RFB NO. 313086 - ADDENDUM NO. 6

### ARCTIC ANIMAL EXHIBIT AND CONCESSIONS

This Addendum is issued to modify, explain or clarify the original Request for Bid (RFB) and is hereby made a part of the RFB. Please attach this Addendum to the RFB. **Bidders must acknowledge all Addenda on the Bid Form.**

#### TYP. CAGEWORK NOTES

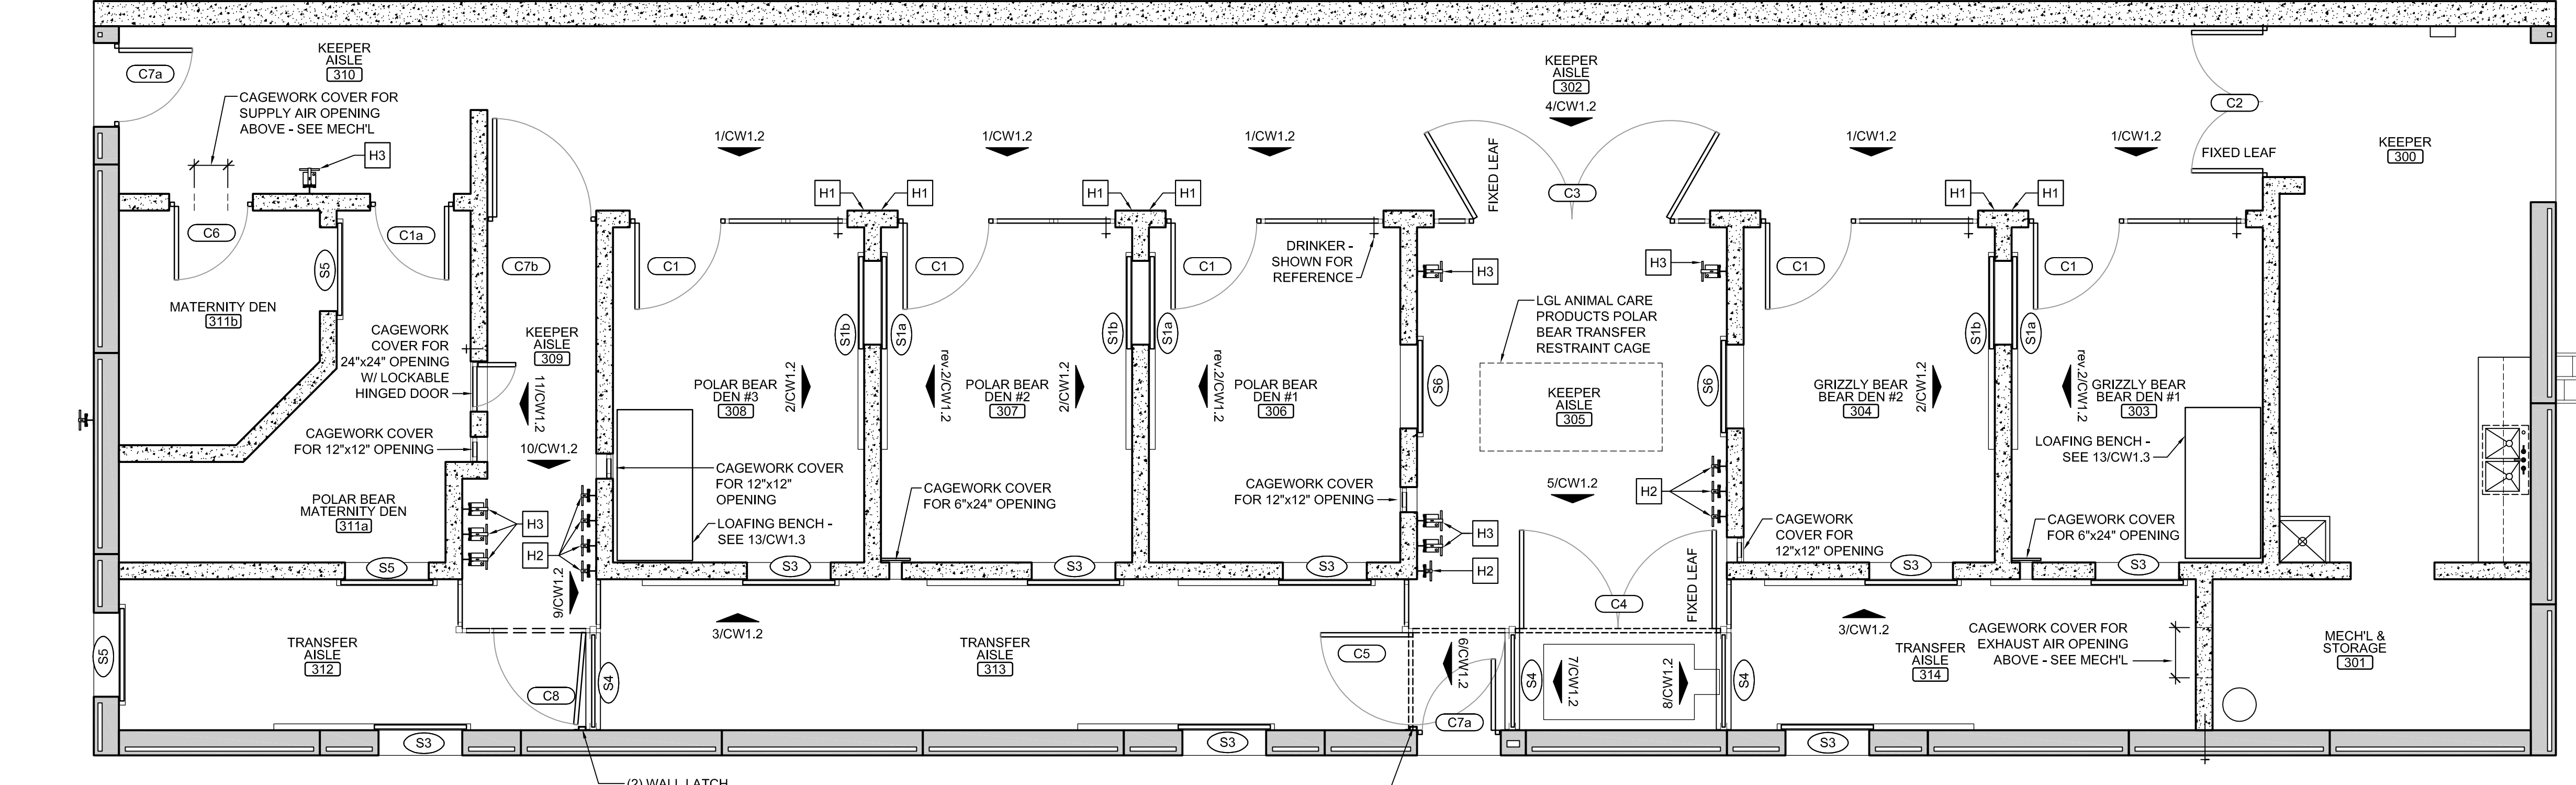
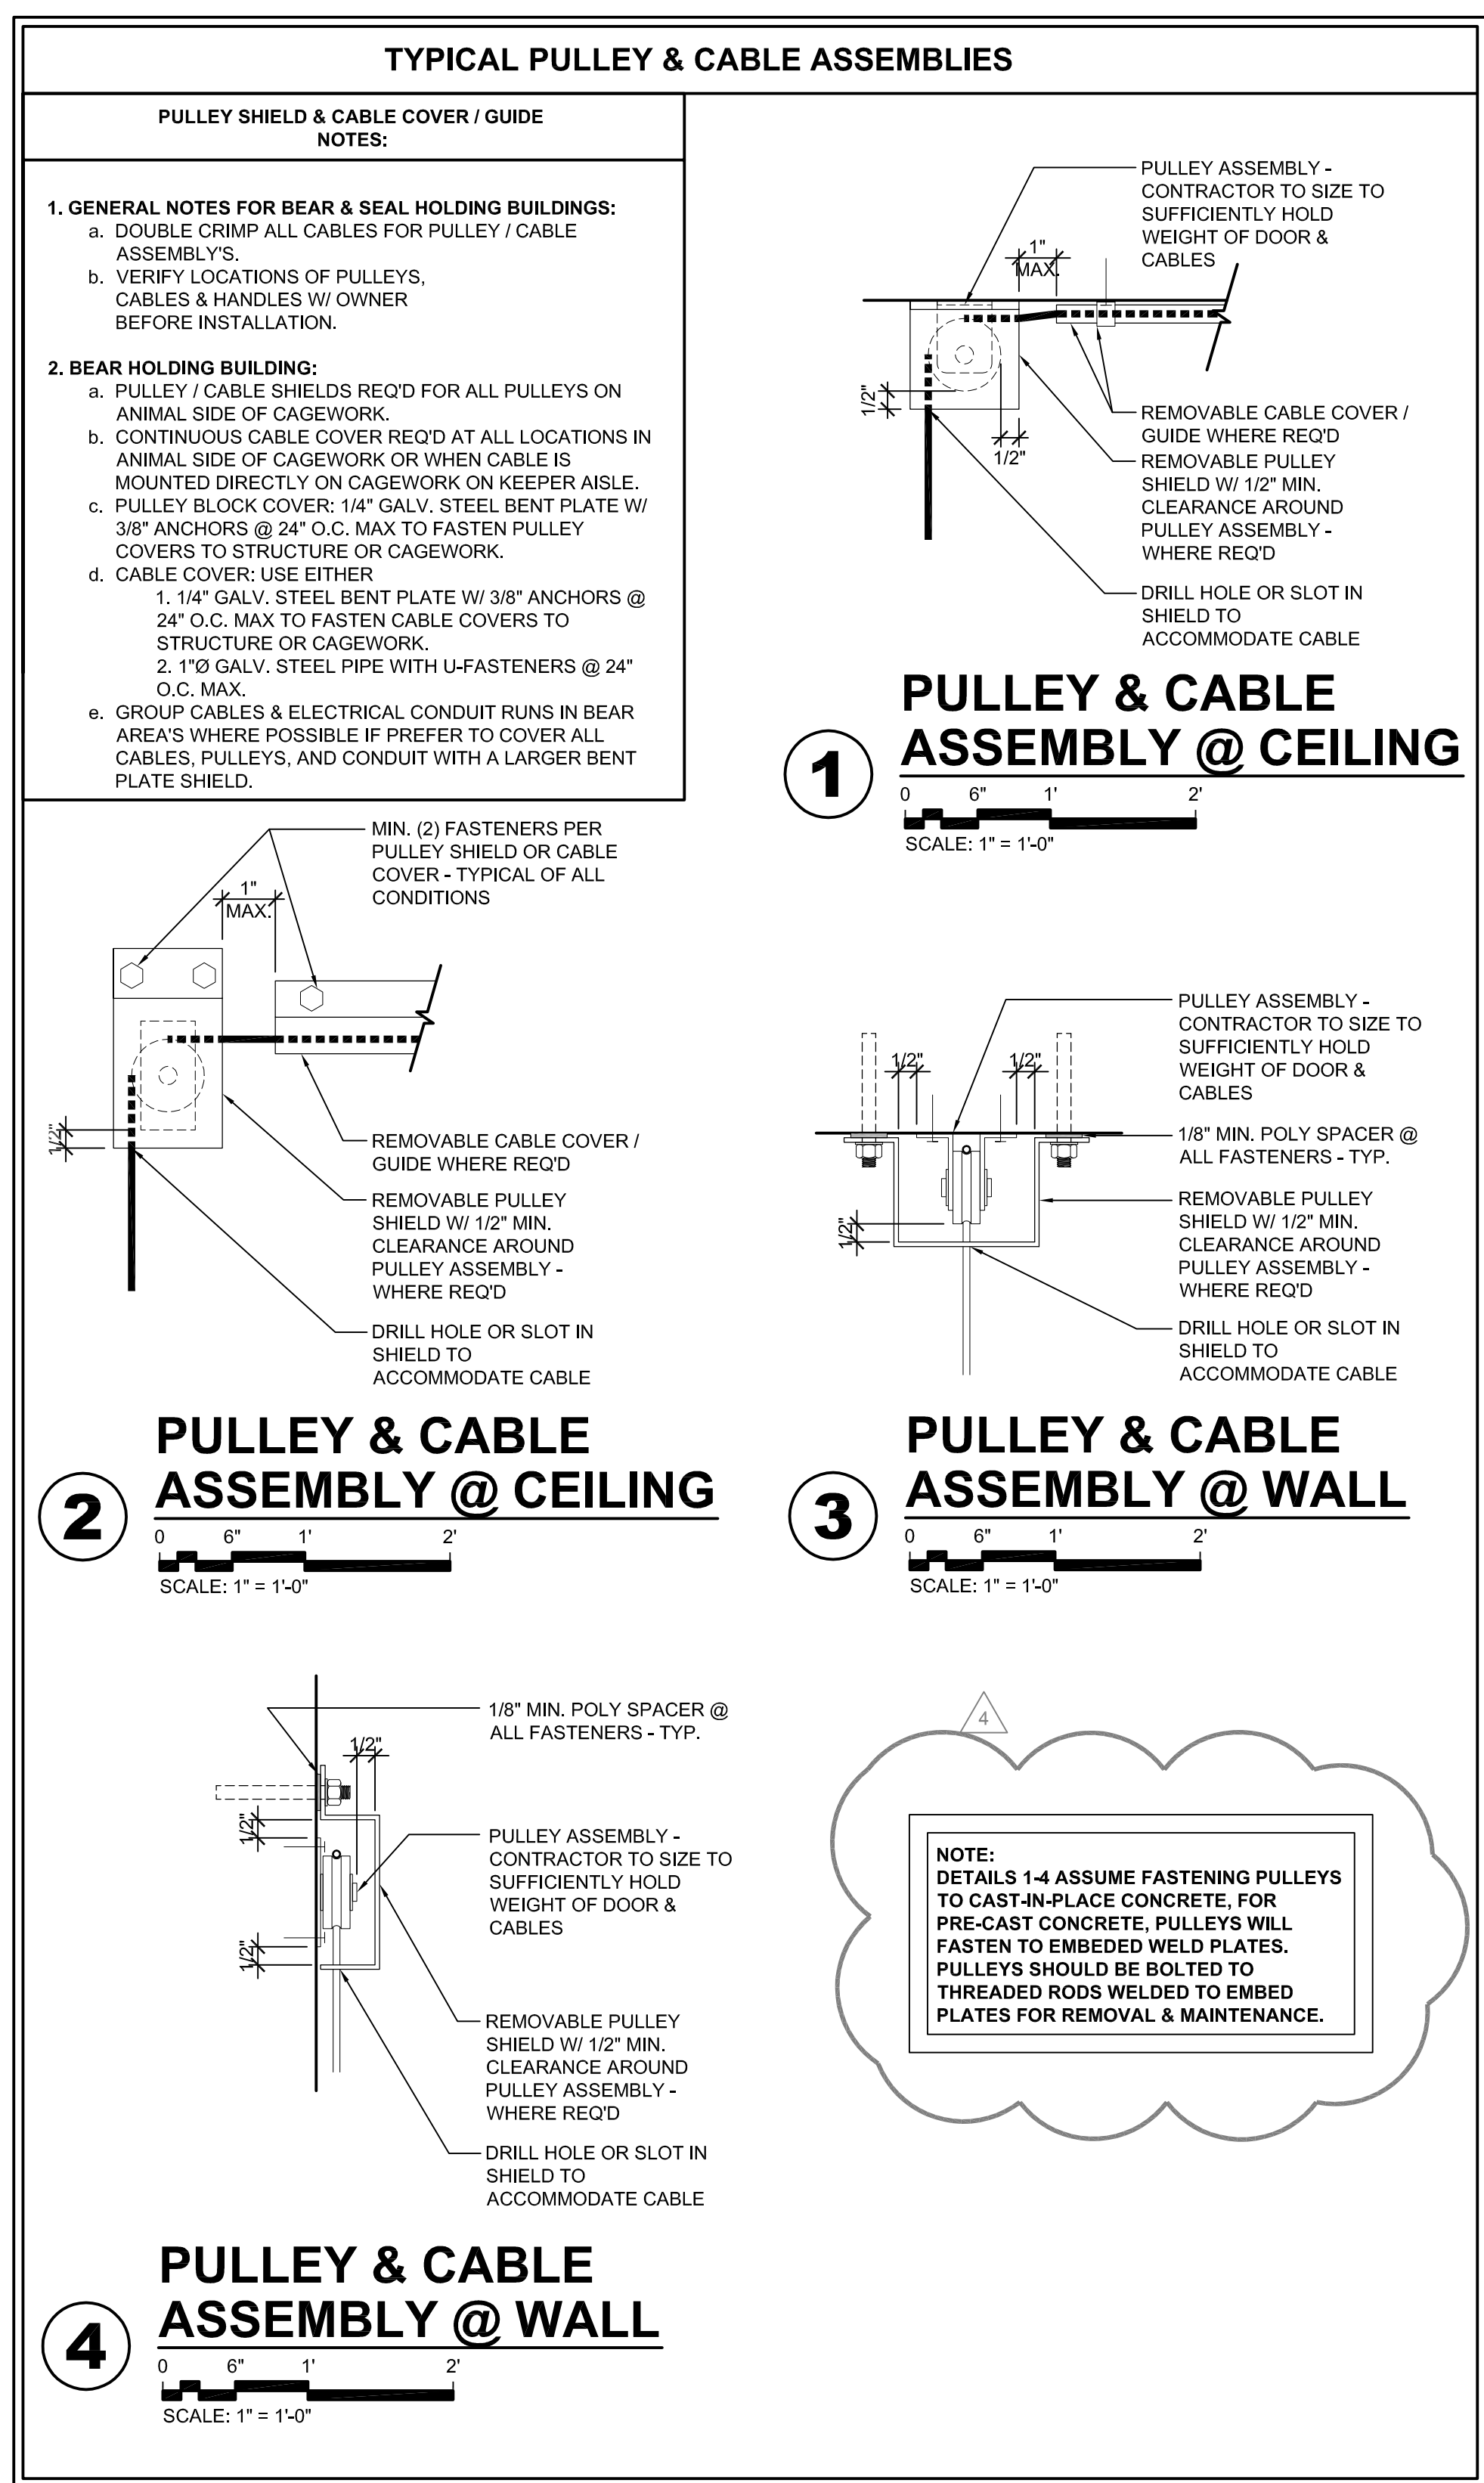
## **22. Sheet CW1.1**

- Revised sheet to show cagework weld plates in the RCP (B/CW1.1) as well as add two new elevations (5,6/CW1.1) indicating suggested approximate locations, size, & quantity of embed plates needed to fasten cagework & related items to precast ceilings & walls. Concrete precaster is to coordinate with cagework contractor for final locations, sizes, & quantity of embed plates. Note that all cable & pulley locations are shown diagrammatic, & final locations will be determined by cagework contractor and are to be coordinated with concrete precaster.
- See note on details 1-4/CW1.1 for pulleys that will be fastened to pre-cast concrete walls & ceilings. In addition, all steel plate pulley covers shields are to be ¼" galv. Steel instead of 1/8" galv. Steel plate.
- Polar Bear Transfer Crate equal to LGL #91190
- Replace existing sheet CW1.1 with new sheet CW1.1 included in this addendum.
